TPS54320 start up waveform

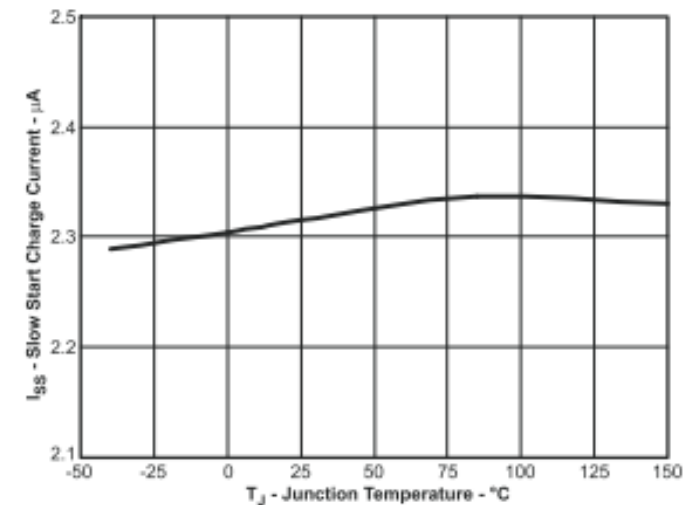
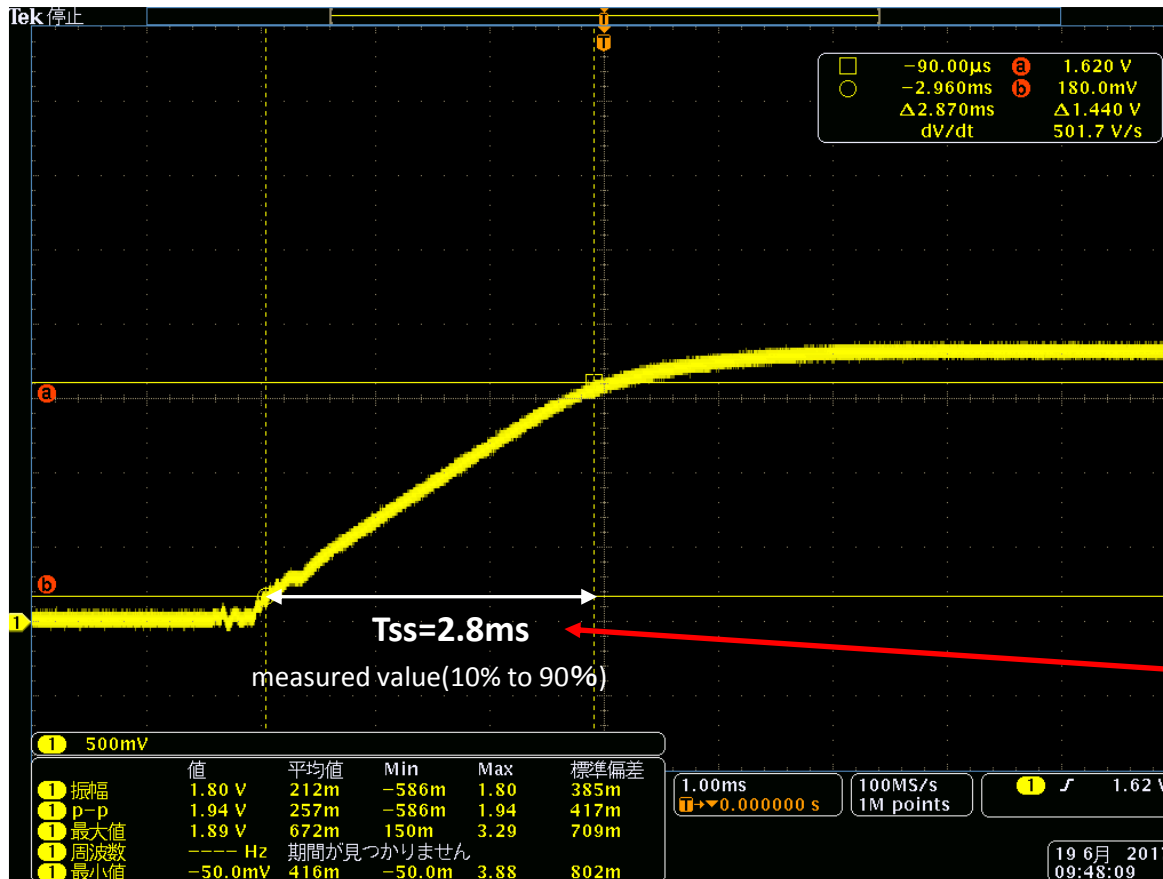
Calculated value:
Tss=3.06ms(min) 3.88ms(max)

C_{ss}=0.01µF(±10%)、
V_{ref}: 0.792~0.808V、
I_{ss}: 2.29~2.33µA

The customer thinks that the measured value should be slower than the calculated value.
Please tell me logically the reason is short rise time towards the measured values.
